## **SSD-10831778 – SYDNEY CHILDREN'S HOSPITAL STAGE 1 AND CHILDREN'S COMPREHENSIVE CANCER CENTRE- RESPONSE TO REQUEST FOR FURTHER INFORMATION**

This letter has been prepared by Urbis on behalf of Health Infrastructure New South Wales (HI), the applicant for the Sydney Children's Hospital Stage 1 and Children's Comprehensive Cancer Centre (SCH1/ CCCC) SSD-10831778. It responds to matters raised by Randwick City Council (Council) in their letter dated 25 October 2021.

Figure 1 – High Street shared space option

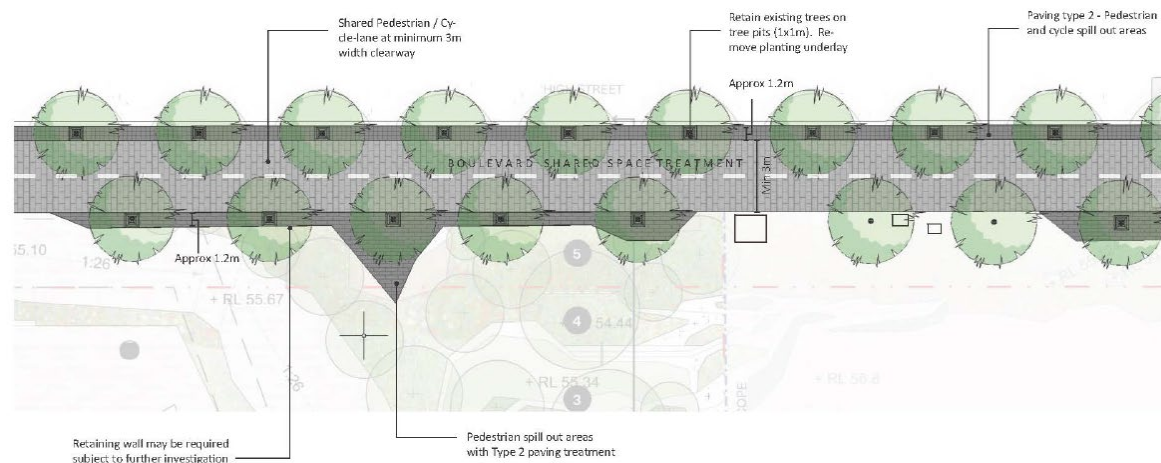
Council's position is that a 3m minimum width footpath to High Street is required deliver a shared pedestrian/ bicycle path along the SCH1/CCCC and HTH project frontages.

Council has prepared a draft sketch for consideration showing how this might be achieved – refer **Figure 1**.

As detailed in the RTS, the widening of the footpath would result in a sub-optimal design solution as:

- it would require the introduction of a 650mm retaining wall with negative impacts on views into the site. This is an important project principle that reduces boundary lines and promotes an inviting and equitable key entry.

- there needs to be physical separation between pedestrians and the existing stormwater infrastructure. This is currently provided by a small planted buffer. Widening of the footpath will increase the risk of conflict. Stormwater pits protrude above the ground level which would prevent a clear unobstructed path and present a safety risk.

- it would diminish the landscape outcome due to the removal of available landscaped area from the design. It is noted that the alternative Council sketch concept shows large trees on the southern boundary of the footpath. Due to the existing services in the area and subsequent soil depths in this location this would not be able to be achieved.

HI has discussed the proposed footpath design with UNSW, and the shared view is that retention of the existing footpath design for SCH1/CCCC and the HTH will provide a consistent approach and the optimal public domain outcome.

Figure 2 - Excerpt of plan showing landscape treatment to ED drop off

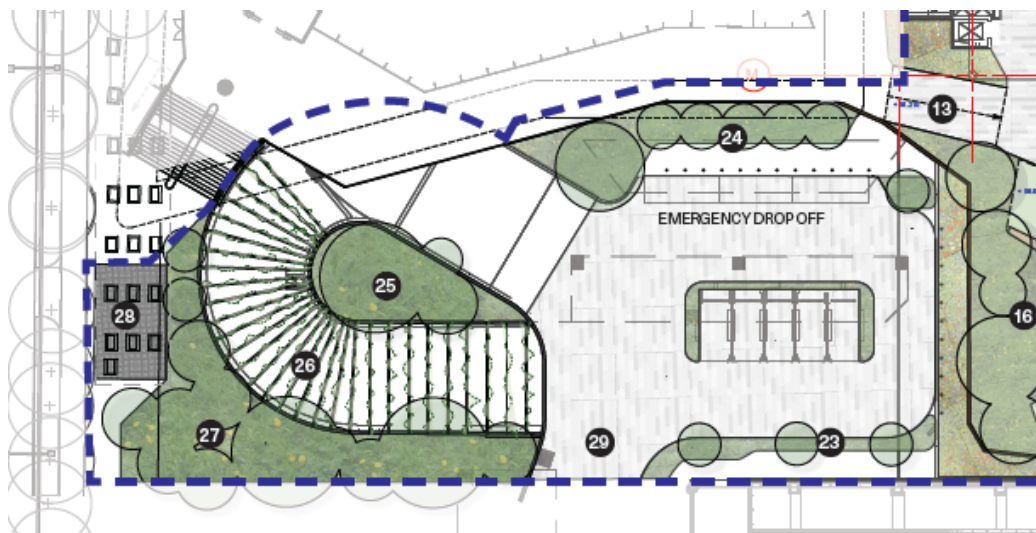
Council has recommended that the proposed emergency drop-off/pick-up area continue to be refined to increase access and amenity for arriving patients and visitors, with measures to be considered including widening of the footpath and entry paving areas where possible and integration of materials or faced treatment to the blank wall adjacent to the 5 northern drop-off bays.

The blank wall referred to by Council contains louvres to the substation that supply the UNSW HTH project. The functional requirements of the substations take precedence over any embellishment and therefore any treatment to this wall will be limited and does not form part of the SCH1/CCCC SSDA.

Widening of the footpath would impact the number of drop off bays that can be provided. The current pathway allows sufficient space for vehicle swept paths navigating the drop off and accommodates the landscaped zone located between this wall and the drop off bays. The proposed landscaping assists in improving the amenity of this area – refer plan excerpt at **Figure 2** below.
